Subject: Oconee Nuclear Station
Docket Nos. 50-269, -270, -287
Adequacy of Station Electric Distribution Systems Voltages

ADEQUACY OF STATION ELECTRIC DISTRIBUTION SYSTEM VOLTAGE

OCONEE NUCLEAR STATION

RESPONSES TO ENCLOSURE OF JOHN F. STOLTZ LETTER TO W. O. PARKER

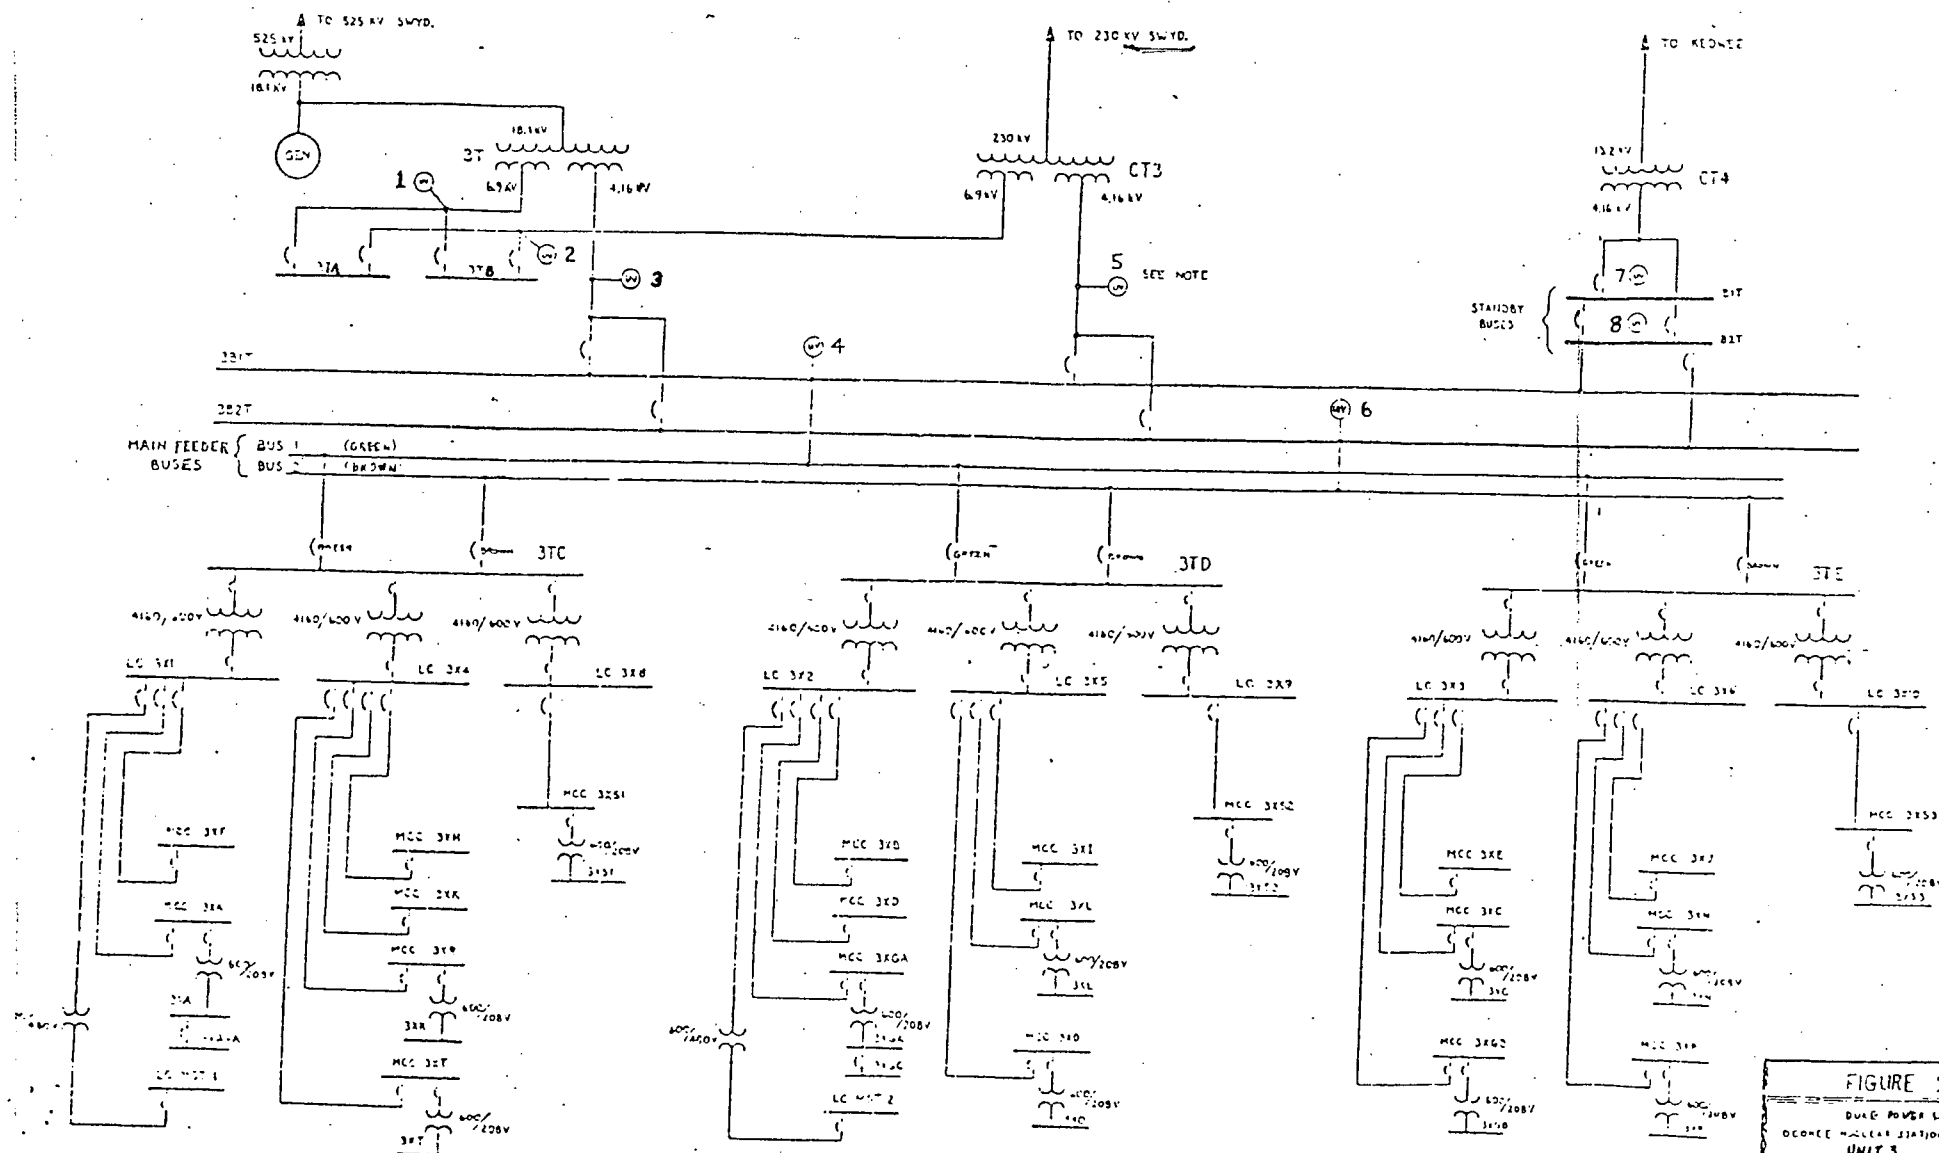
Describe the loss-of-voltage and degraded voltage relaying, including location of relays, coincidence logic and search scheme. Provide a graph that shows two plots (relay characteristics (including tolerances) and the worst case analyzed voltage transient). This should show that there is no possibility of spuriously tripping the offsite source due to minimum analyzed conditions.

The characteristics of the Emergency Power Switching Logic undervoltage relays which will separate a unit from the offsite source are shown in Figure 2. Also plotted in Figure 2 are the transient voltages during starting of the unit LOCA loads plus starting a large non-safety motor (Condensate Booster Pump Motor) following a LOCA, with the grid voltage at its historic low and the startup supplying the load. Figure 2 demonstrates sufficient margin exists between the worst case analyzed voltage transients and the undervoltage relay (CV-7) to preclude the possibility of spuriously tripping the offsite source.

The undervoltage relays associated with the unit auxiliary transformer serve to separate the 4.16KV system from an unacceptable voltage supply during unit power operation or when backfeeding the unit auxiliaries through the main stepup and auxiliary transformer with the generator disconnect links removed. The CV-7 relay characteristics are shown in Figure 2.
